**City Council Questions and Answers for
Thursday, April 14, 2016**

1. Agenda Item # 16: C14-2014-0198 - One Two East - District 1 - Conduct a public hearing and approve an ordinance amending City Code Chapter 25-2 by rezoning property locally known as 1109, 1105, and 1107 North IH 35 Service Road Northbound (Waller Creek Watershed) from general commercial services-neighborhood conservation combining district-neighborhood plan (CS-NCCD-NP) combining district zoning to general commercial services-neighborhood conservation combining district-neighborhood plan (CS-NCCD-NP) combining district zoning for Tract 1, and from commercial-liquor sales-neighborhood conservation combining district-neighborhood plan (CS-1-NCCD-NP) combining district zoning to commercial-liquor sales-neighborhood conservation combining district-neighborhood plan (CS-1-NCCD-NP) combining district zoning for Tract 2. Staff Recommendation: To grant general commercial services-neighborhood conservation combining district-neighborhood plan (CS-NCCD-NP) combining district zoning, to change a condition of zoning for Tract 1, and commercial-liquor sales-neighborhood conservation combining district-neighborhood plan (CS-

ATTACHMENT A

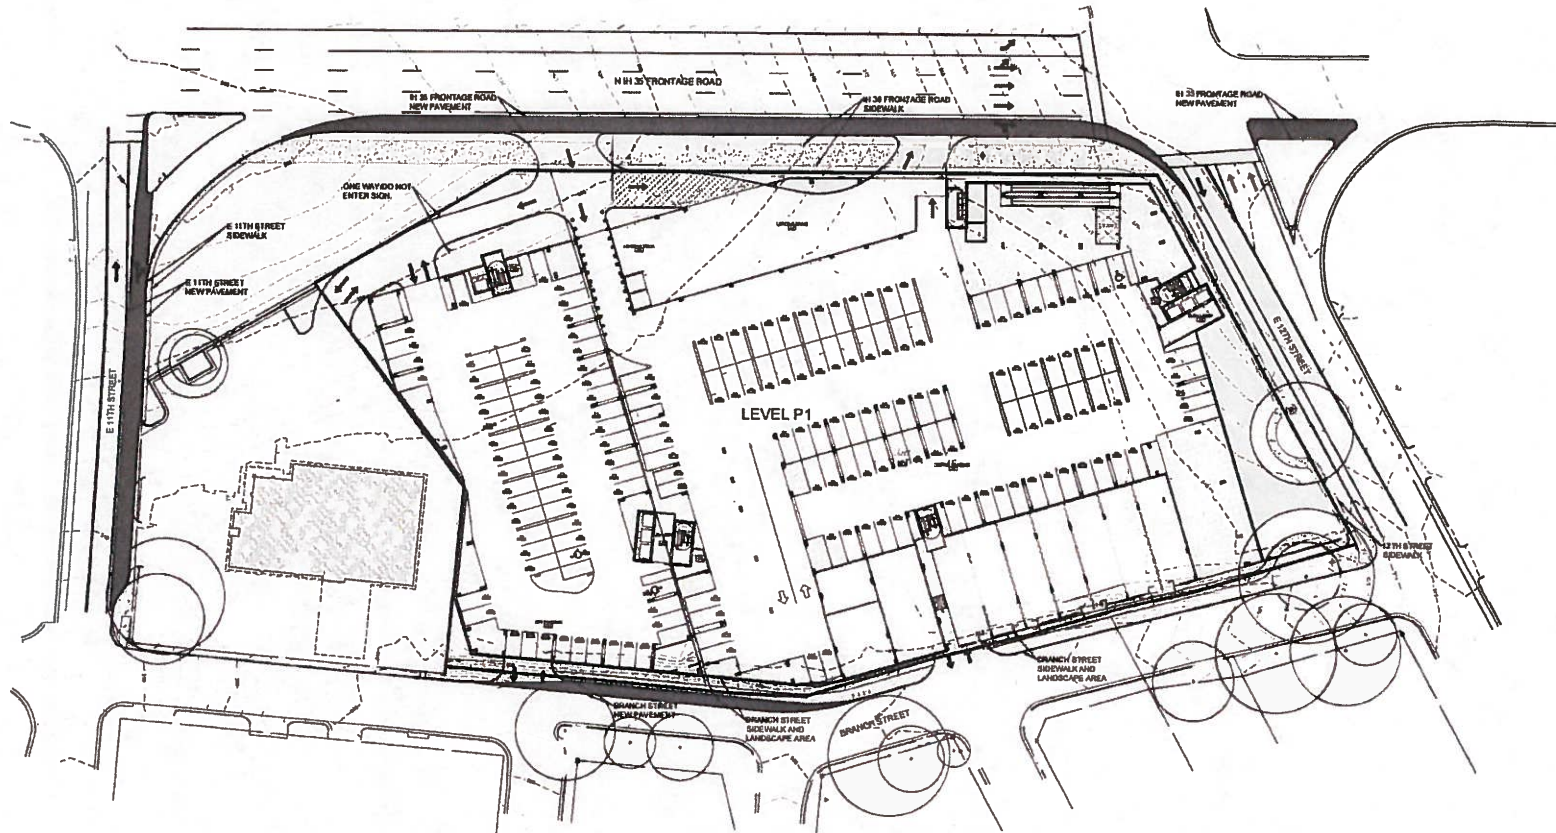
14) Proposed traffic improvements include additional pavement on the northbound frontage road of IH-35, north of East 12th Street. Please provide a site plan to demonstrate where additional pavement is proposed, including how far north of East 12th Street it is proposed how far east of current pavement.

15) Please provide a complete site plan that shows all proposed traffic improvements from East 11th Street to East 12th Street, Branch Street to IH-35, including proposed dedicated right turn lane (East 11th), all street widening and the sidewalk network.

Please see attached site plan. The dark gray area indicates the additional pavement. ATTACHMENT A

The site plan attached for number 14 above shows all proposed traffic improvements as well.

FIGURE 15
2018 Site Plus Forecasted
Geometric and Traffic
Volume Conditions

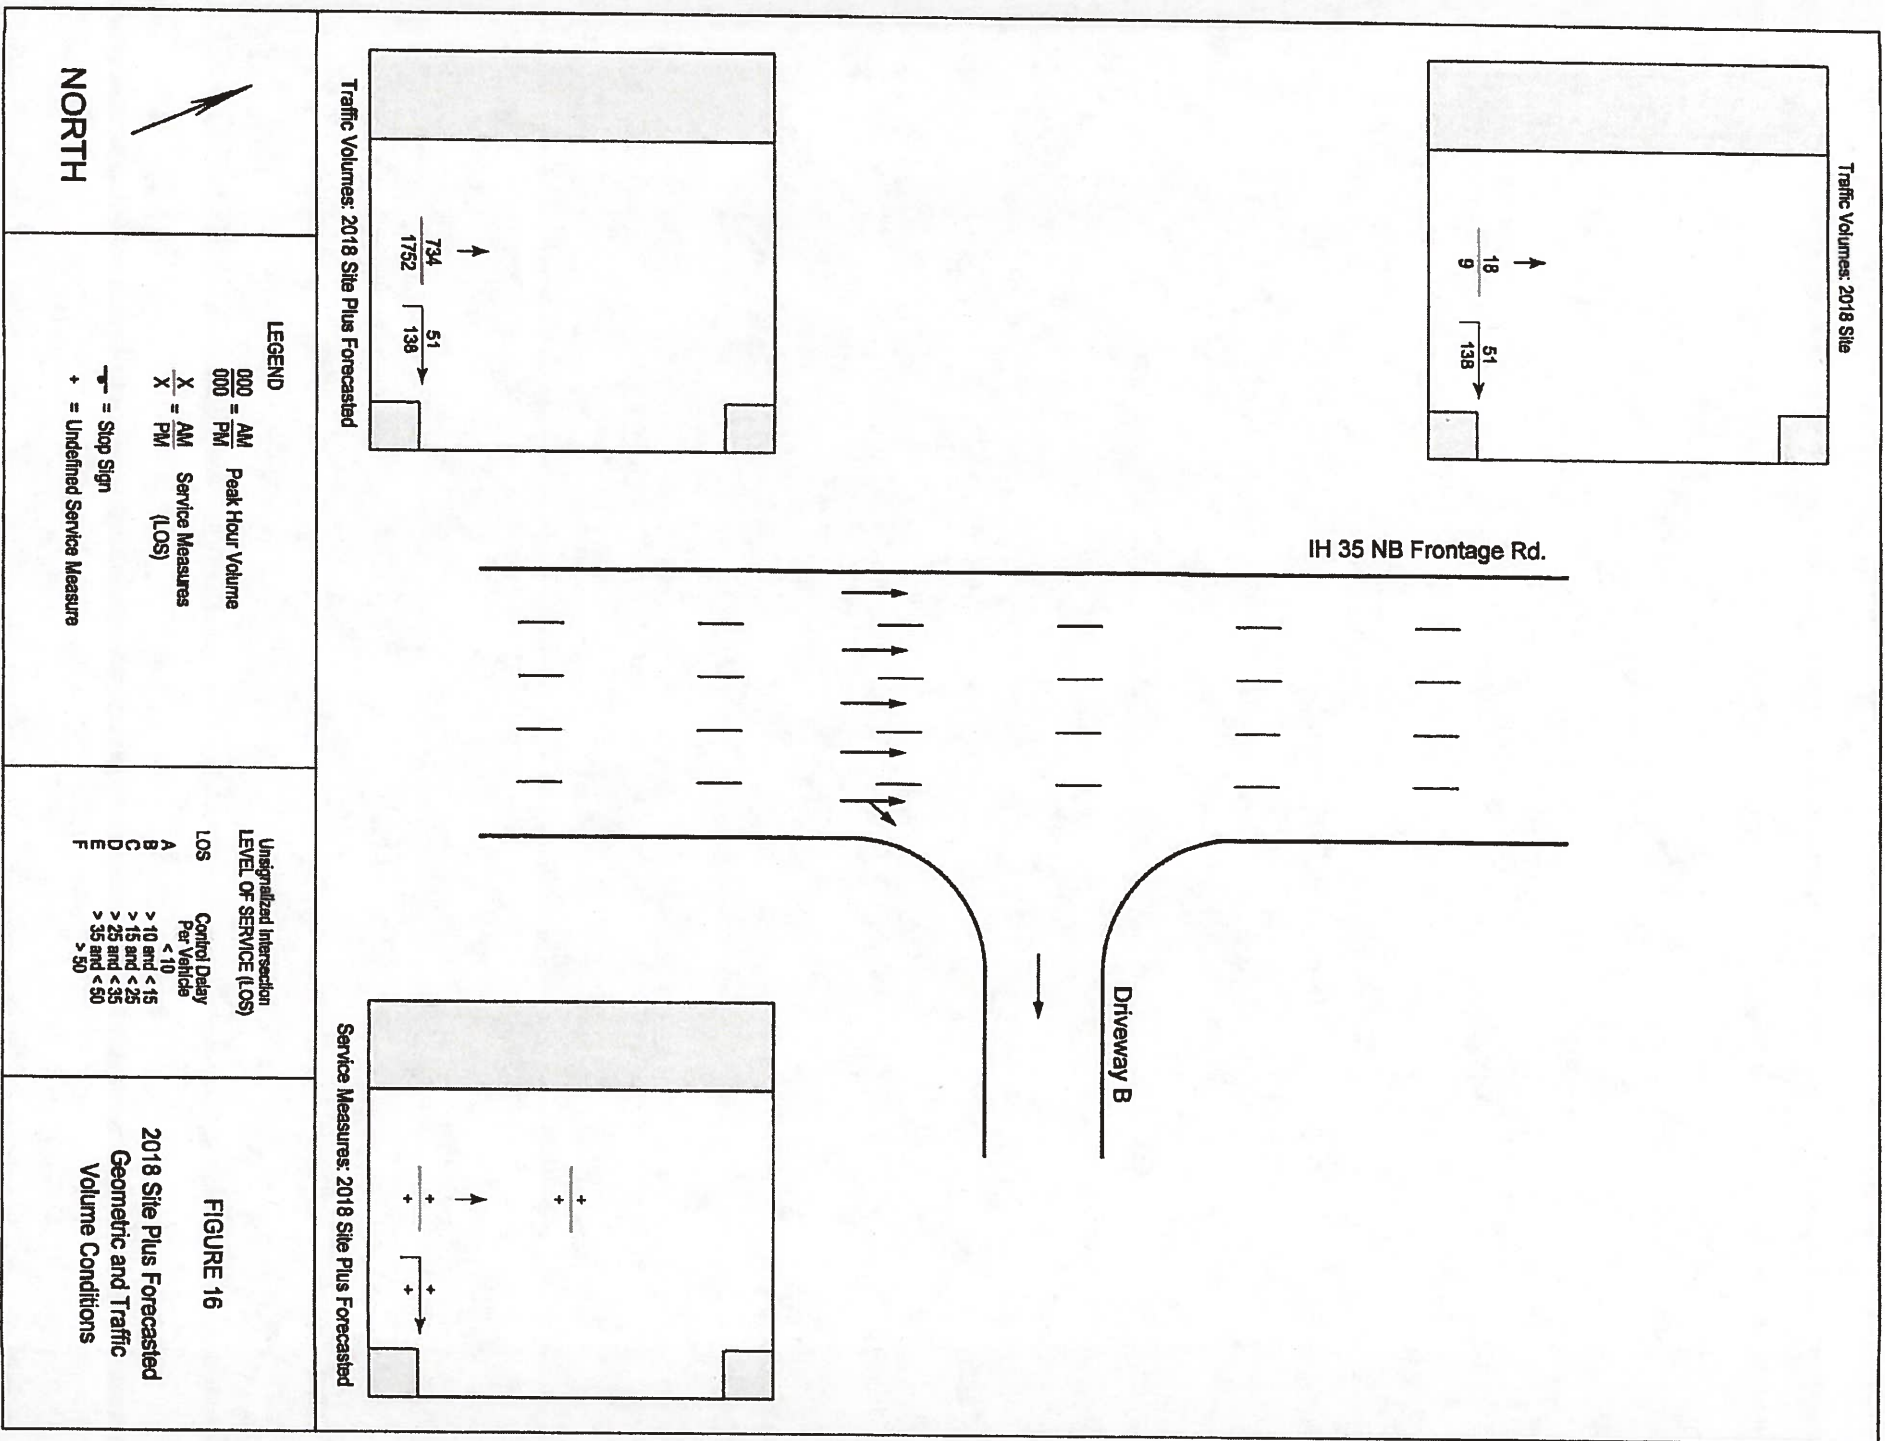
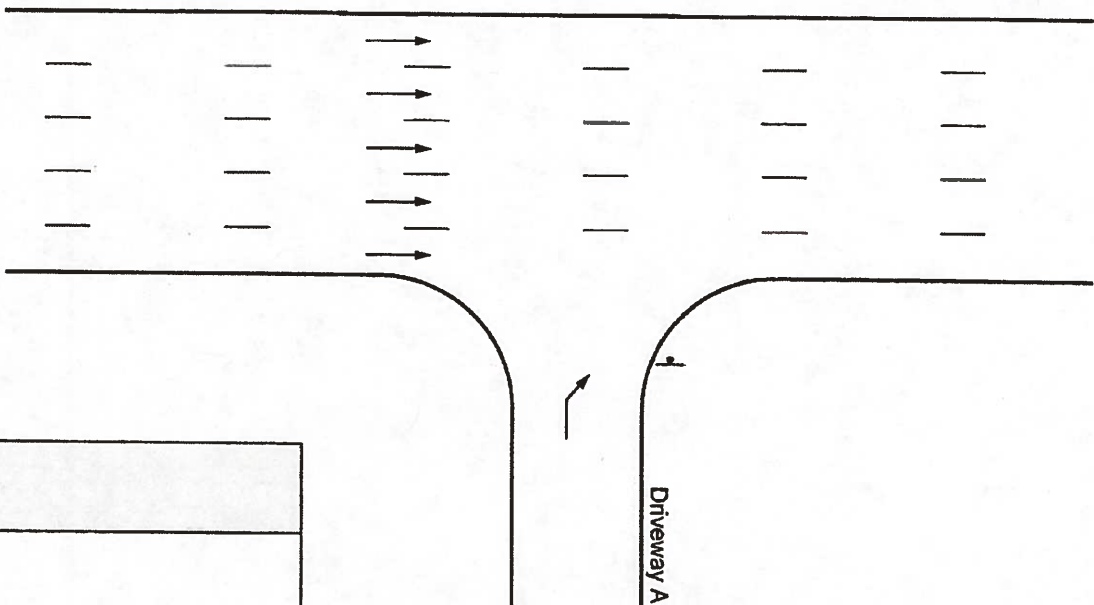
16) Please provide most recent updated exhibits to the approved Traffic Impact Analysis.

Please find attached revised exhibits which reflect the revised driveway trip assignments. These numbers reflect peak hour trip estimates. ATTACHMENT B

ATTACHMENT C

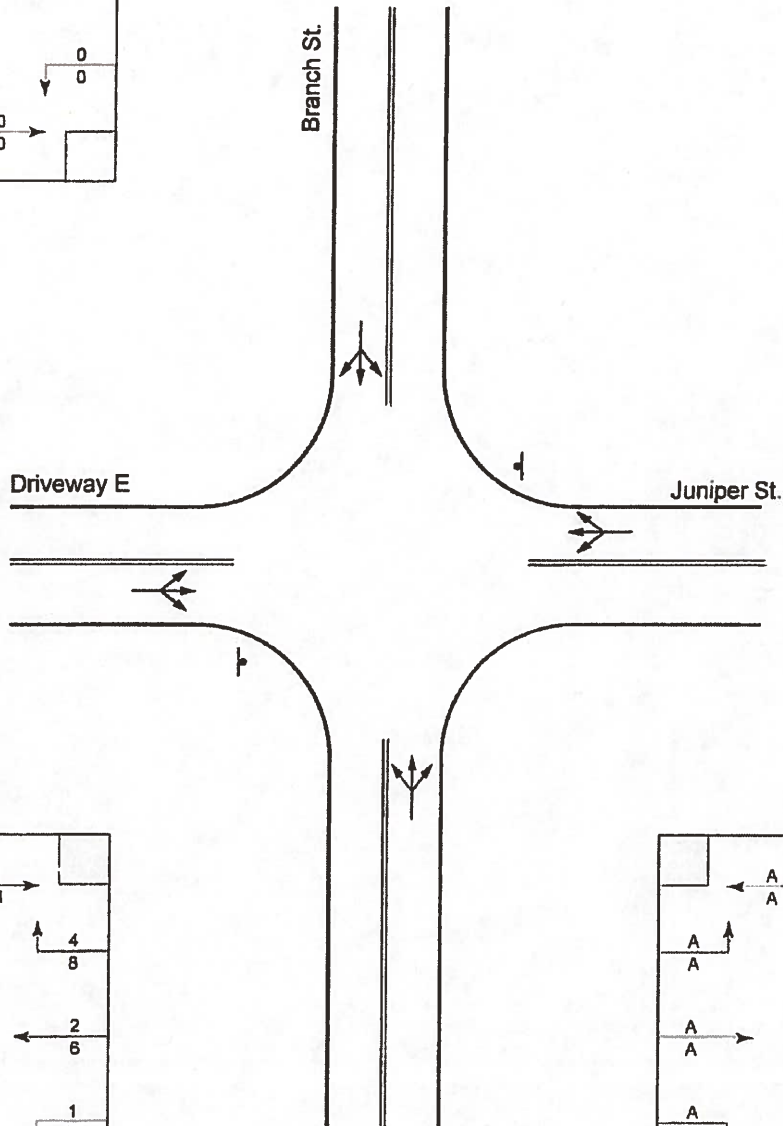
18) Please provide the plan to minimize negative impact to adjacent and nearby residents during demolition, excavation and construction.

Austin Commercial will include the attached 'No Parking Map' diagram in our subcontractor's subcontract agreements, therefore allowing us to enforce towing of any subcontractor vehicle in violation. In addition, Austin Commercial will look to provide offsite parking areas that workers can be bused from. These areas will need to be identified closer to the construction start dates. This is typical for all their high density projects with little to no adjacent parking. ATTACHMENT C
